## LINCOLN PARK PLANNING COMMISSION

August 11, 2021 at 7 p.m.

### Site Plan Review

Applicant	Roger Canzano
Project	Auto Sales
Address	881 Southfield Rd. Lincoln Park, MI 48146
Date	August 11, 2021
Request	Site Plan Review

**SHEET TITLE**  
**PROJECT NAME**  
 ADD USED CAR SALES TO  
 EXISTING AUTO REPAIR  
**SITE PLAN**

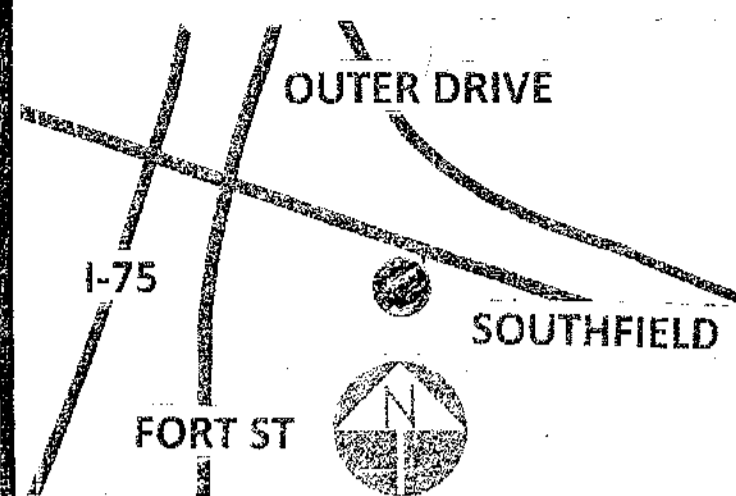
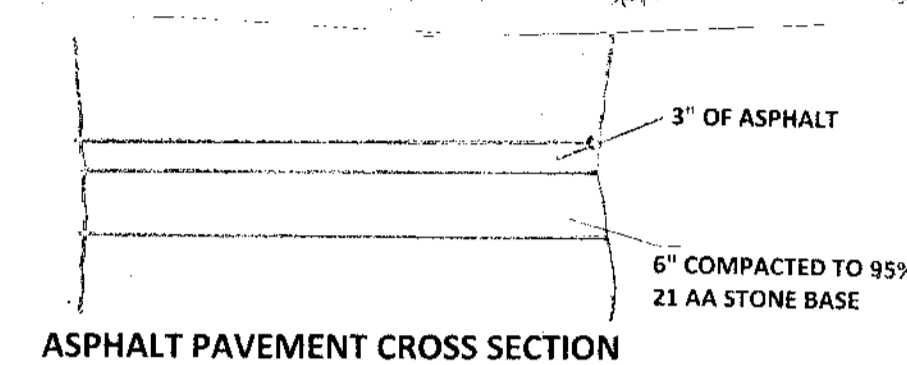
The site is served by an existing light pole located on the corner of Southfield Rd and Wilson Ave. The Site Plan, sheet 01 and Elevations, sheet 06 indicate two outdoor light fixtures with shields, one on the left side elevation facing the auto display area and one on the left side elevation facing the Wilson Ave. The existing lighting appears to be shielded and downward facing.

The proposed use is expected to generate some quantity of hazardous materials or waste. Sheet 01 Site Plan notes that the applicant will provide primary and secondary containers inside the building for the storage of removed vehicle fluids. Applicant shall provide documentation of compliance with State and Federal standards for storage, use, handling, and disposal.

**Sheet 01**

6. The current plans do call for a new 6.5 foot walk along the front of the building.
7. The plans do call for replacing the existing asphalt parking lot in front of the building. Pavement details and cross-sections can be provided at the time of the detailed engineering review.
8. The plans call for parking on the east side of the building. This area on the east side of the building is concrete in very good condition. The parking lot calls for new striping.
9. The east drive approach from Southfield Road will remain unchanged.

- Applicant shall ensure that existing and new concrete sidewalks are brought up to City standards.
- Applicant shall provide details and cross sections of the proposed sidewalk at the time of the detailed engineering review.
- Applicant shall ensure that no cars will be parked from the proposed sidewalk to the road.

- A parking waiver is requested from the Planning Commission to reduce the number of required parking spaces from 13 to 6. Factors for consideration are the size constraints of the site and the availability of on-street parking.
- Applicant shall replace the existing asphalt and bring all parking areas up to City standards.
- Applicant shall provide pavement details and cross-sections at the time of the detailed engineering review.

- Applicant shall provide the one required barrier-free parking space that is 12’ wide.

ELEVATIONS

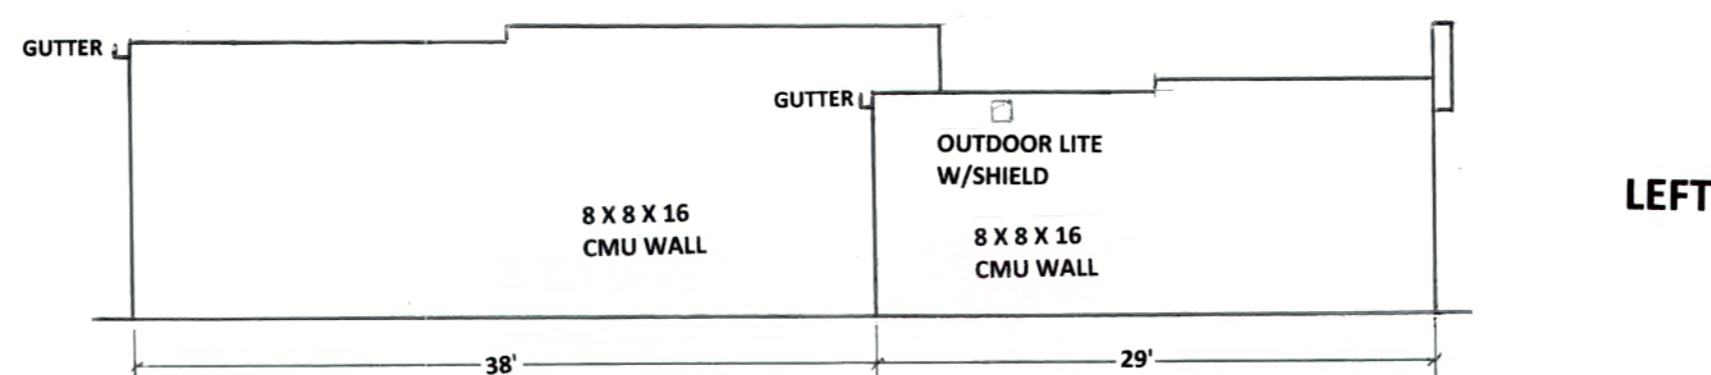
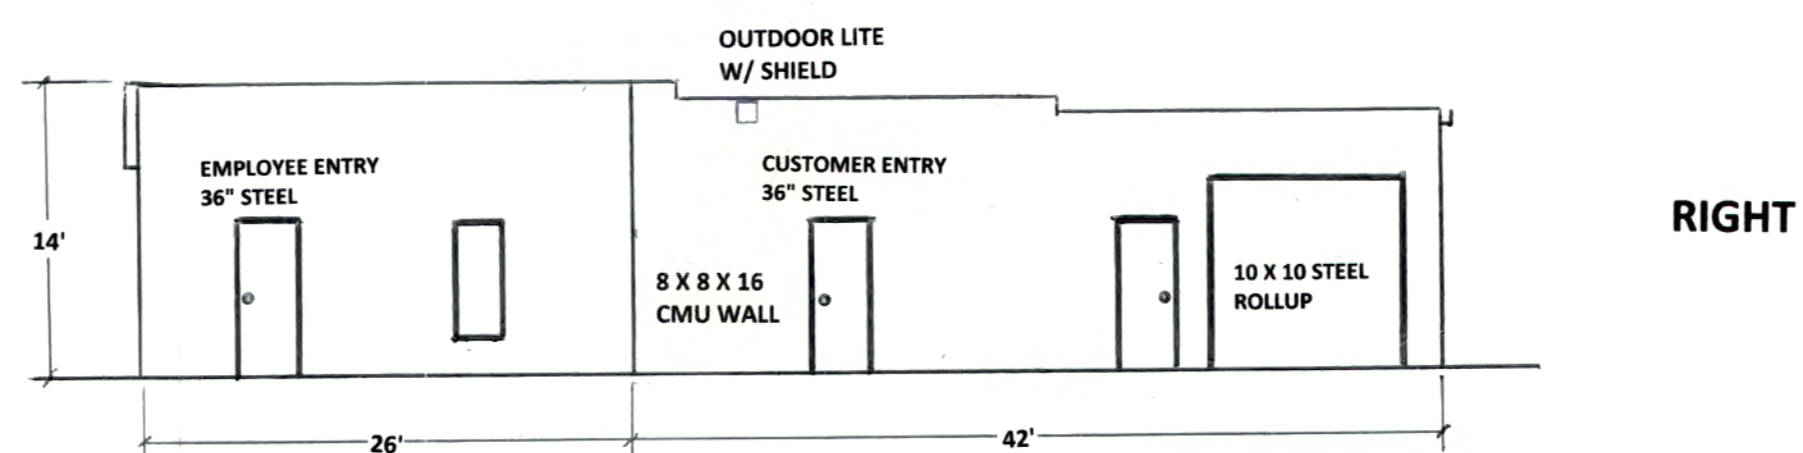
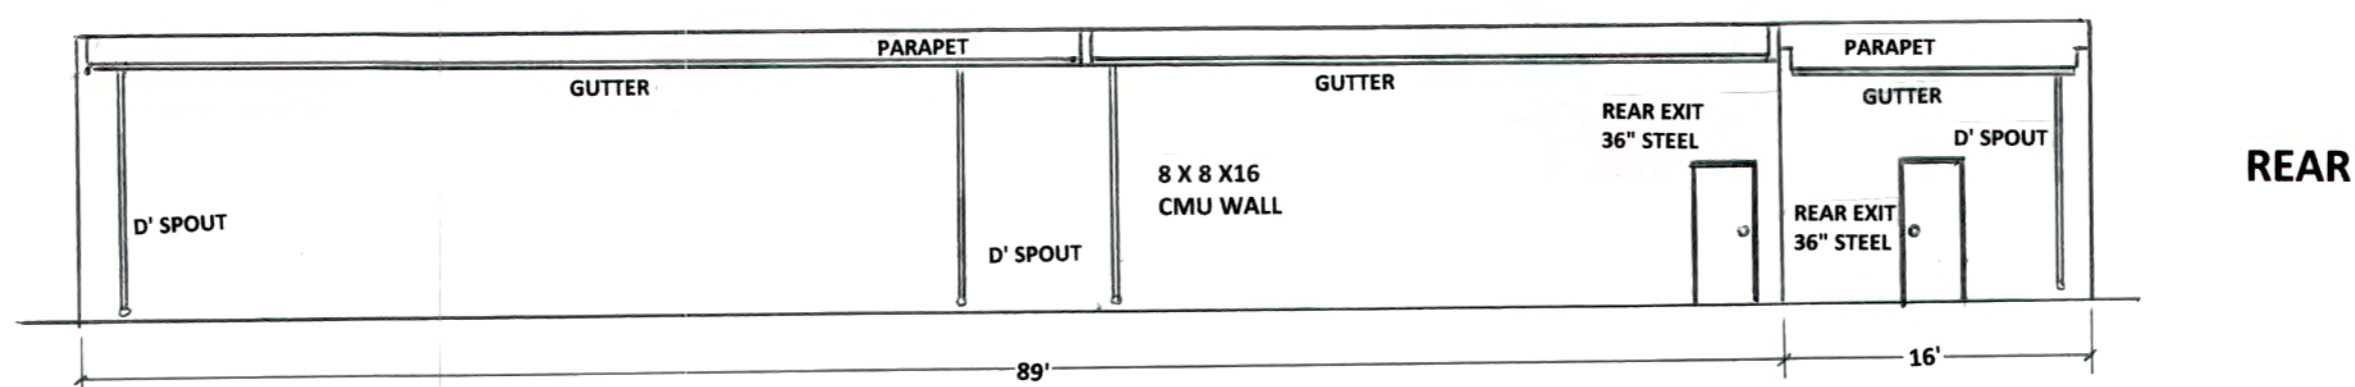
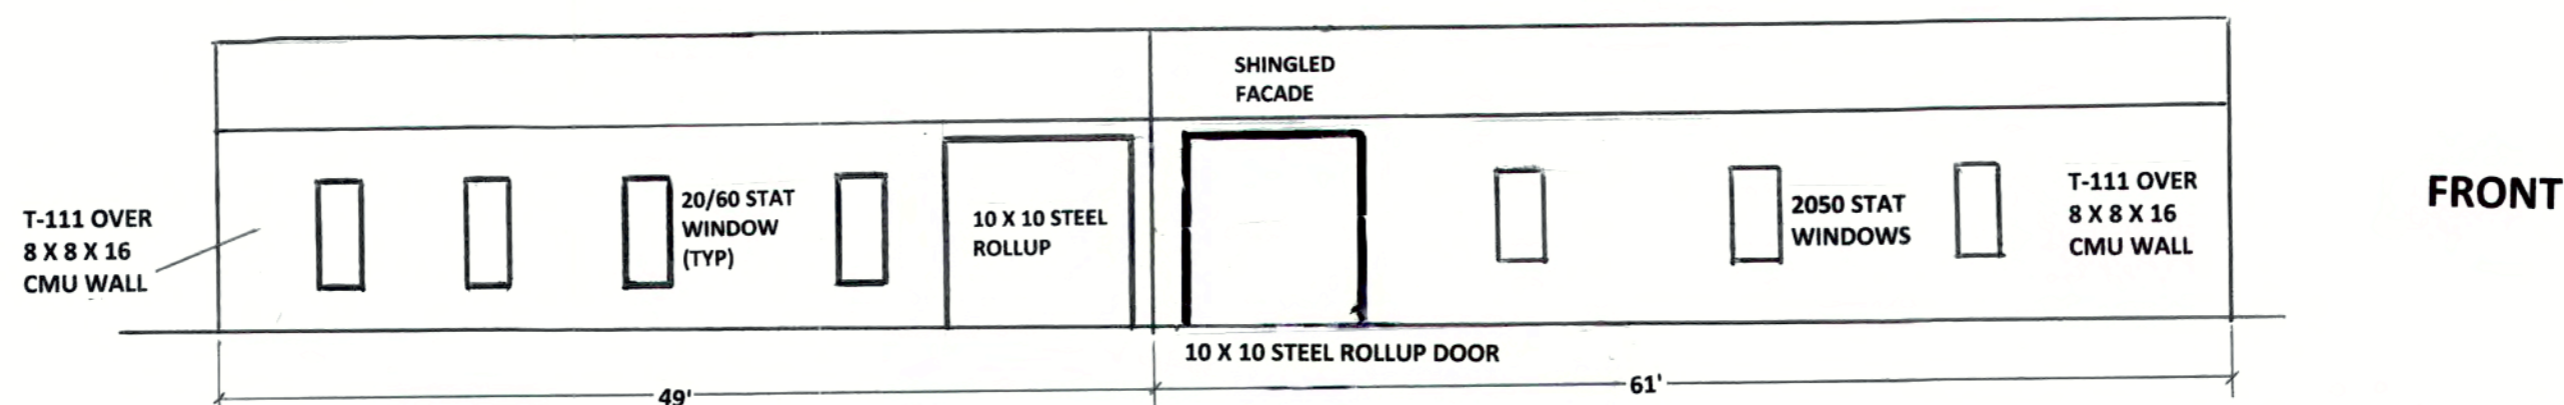
Required	Compliance
<ul style="list-style-type: none"> <li>Building mass, height, bulk and width-to-height ratio within 50-150% of buildings within 500'</li> </ul>	Met
<ul style="list-style-type: none"> <li>Architectural variety</li> <li>Similar materials and entrances to buildings within 500'</li> </ul>  <p>Figure 3: The site; Southfield Rd and Wilson Ave corner</p>  <p>Figure 4: Southfield Rd looking East</p>	Met
<ul style="list-style-type: none"> <li>Building materials: primarily natural products conveying permanence (brick, decorative masonry block, stone, or beveled wood siding) = 75% of each façade (industrial districts, 50% if facing ROW)  <u>Front (facing Southfield): 58% (878 sf / 1525 sf)</u>                      Beveled wood siding over CMU wall: 878 sf                      Shingled roof: 467 sf                      Windows (exempt): 86 sf                      Metal doors: 180 sf                      Total: 1,611 sf  <u>Rear (facing alley): 87% masonry (1,338 sf / 1,543 sf)</u>                      CMU wall: 1,338 sf                      Parapet: 159 sf                      Metal doors: 46 sf                      Total: 1,543 sf  <u>Right (facing Wilson): 81% masonry (785 sf / 965 sf)</u>                      CMU wall: 785 sf                      Shingled roof: 3 sf                      Window (exempt): 15 sf                      Metal doors: 177 sf                      Total: 980 sf  <u>Left (facing east): 99% masonry (927 sf / 931 sf)</u>                      CMU wall: 927 sf                 </li> </ul>	NOT MET

3 EXISTING ARCHITECTURAL SITE PLAN

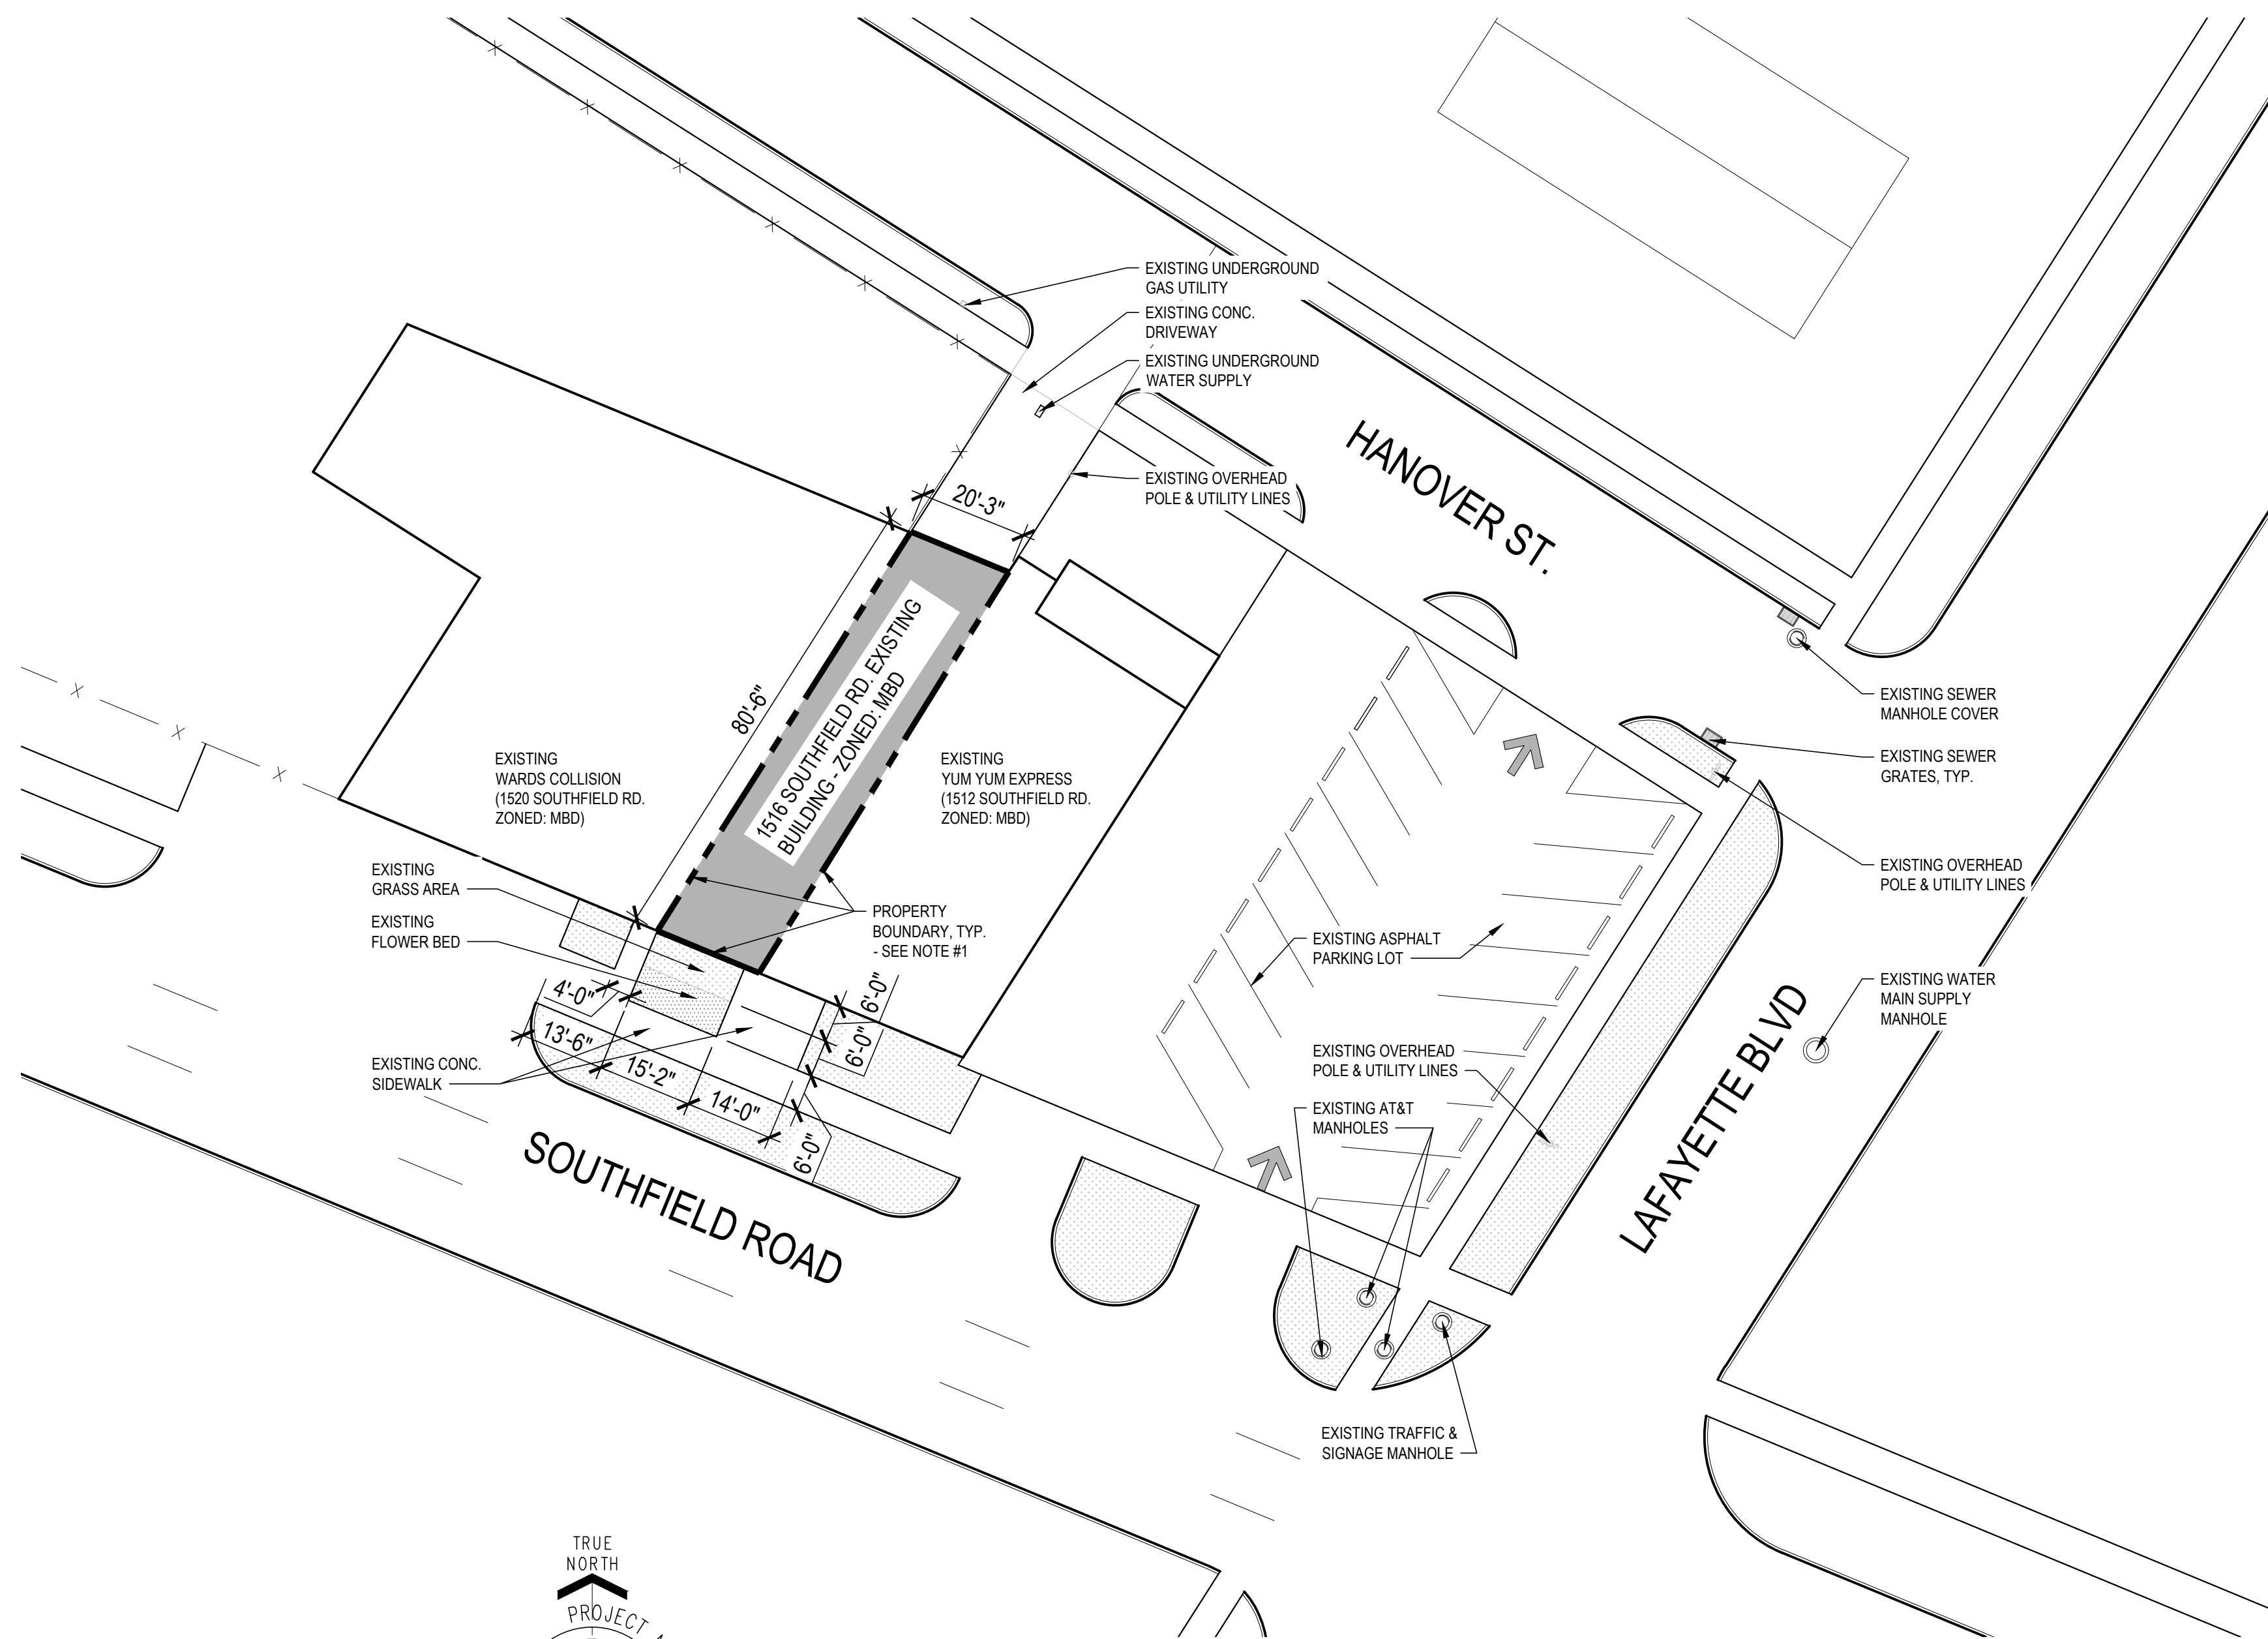
Use	Required	Proposed	Compliance
Office	Three and one-half (3½) for every one-thousand (1,000) square feet of gross floor area.  $1,660 \text{ sq. ft.} / 1,000 = 1.66$ $1.66 \times 3.5 = 5.81 = 5 \text{ spaces}$	2 existing parking spaces (not shown on plan)	<b>NOT MET</b>

The applicant and occasionally an employee will be the only people onsite, and the site is not open to the public. Therefore, the two existing parking spaces should adequately serve the parking needs for the use. Given the extremely limited ability of the site to accommodate parking, it is the Planning Commission’s responsibility to determine whether the proposed parking plan offers adequate provision for the intended use while preserving the public health, safety, and welfare.

- Applicant shall show the existing two parking spaces on the plan.*

- Applicant shall ensure that existing concrete sidewalk in the rear is brought up to City standards.*
- Applicant shall move the adjacent property owner's dumpster off the property.*
